Hydro One Networks Inc.

EB-2007-0050 – Hydro One Networks' Section 92 Bruce - Milton Transmission Reinforcement Application – Hydro One Networks' Response to Interrogatory Questions from Fallis, Fallis & McMillan

Fallis INTERROGATORY #1 List 1

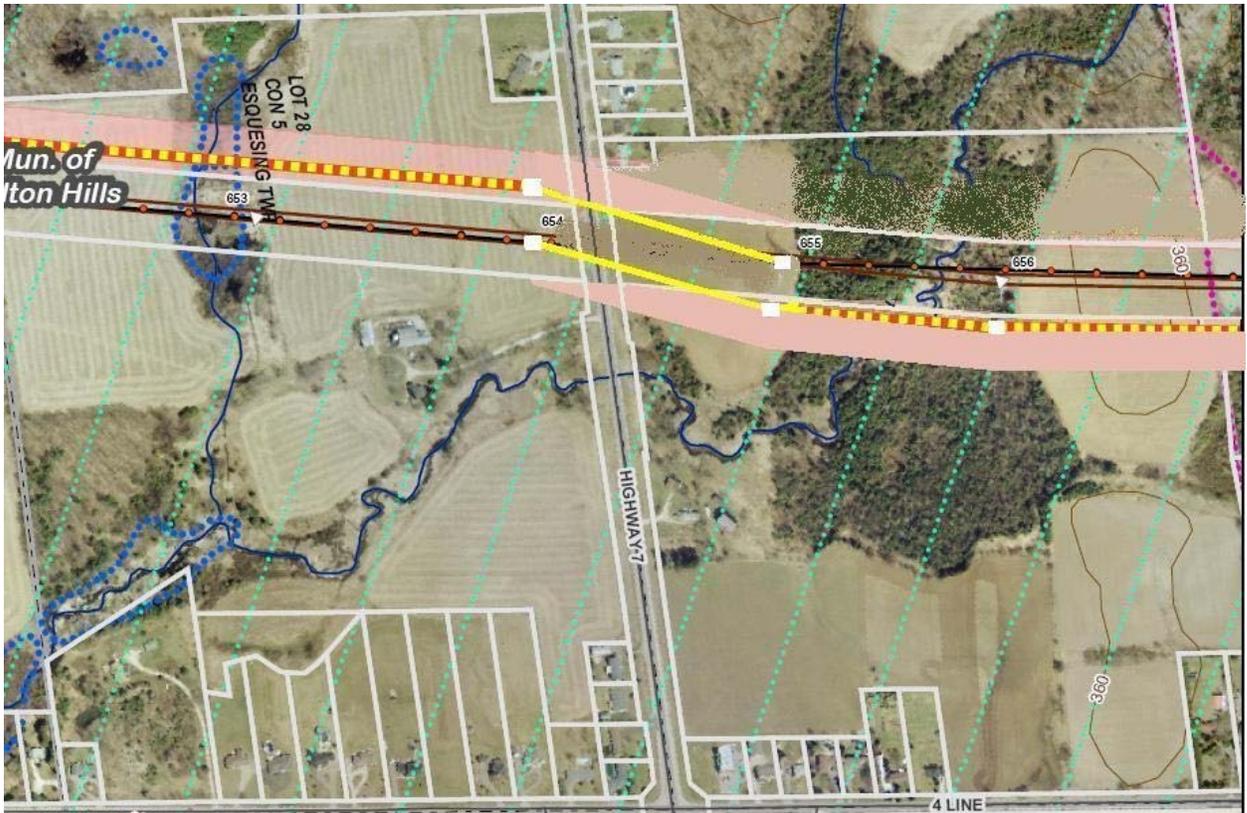
Should the final siting of the Towers to be constructed for the proposed 500 KV Transmission Line in this Application (and for which leave may be granted by the OEB), require that the transmission corridor cross over the existing 500 KV line as built in the late 1970's from Bruce to Colbeck to Milton,

- a) is there an existing design template for such a turning tower, both at the initiation of the cross-over and at the end of the cross-over ?
- b) how high and wide is the tower ?
- c) how much measured distance must the crossing power lines stay removed and above the existing 500KV Transmission Line being crossed ? and
- d) what is the estimated cost of construction of each such type crossing-turning tower.

Rather than a crossing of the existing B x M 500kV line, a circuit switch-over is proposed as part of the route refinement options under study in Halton Hills. This has technical and system advantages to a crossing of 500kV circuits. This switch-over (see attached sketch) would involve:
